INSTITUTION: Durham College of Applied Arts and Technology

RFP NAME: Whitby Campus Cottage Improvements

RFP #: RFPDC11162021

ADDENDUM NAME: Questions and Responses

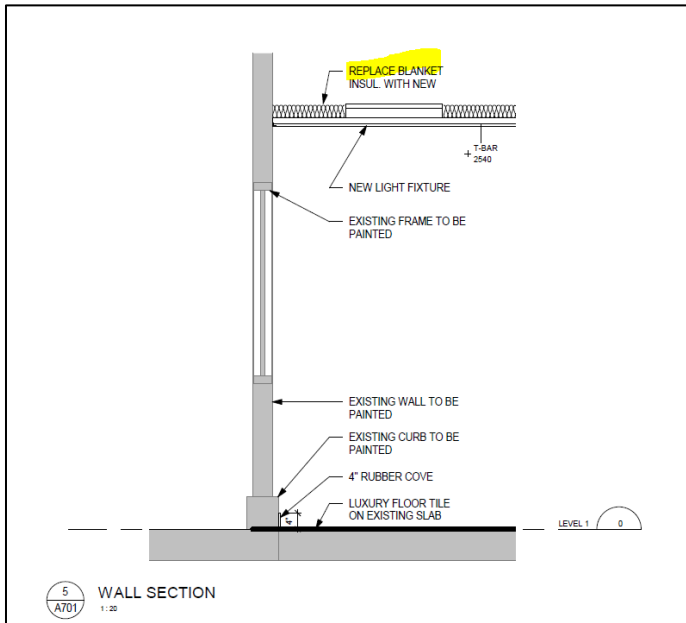
- 3) In reference to section 5-A701, new light fixtures are shown on the drawings. Please provide specifications / electrical drawings if we are to include for these fixtures in our price.

RESPONSE: Refer to Addendum 3. See Electrical drawings E1 for Fixture type Schedule.
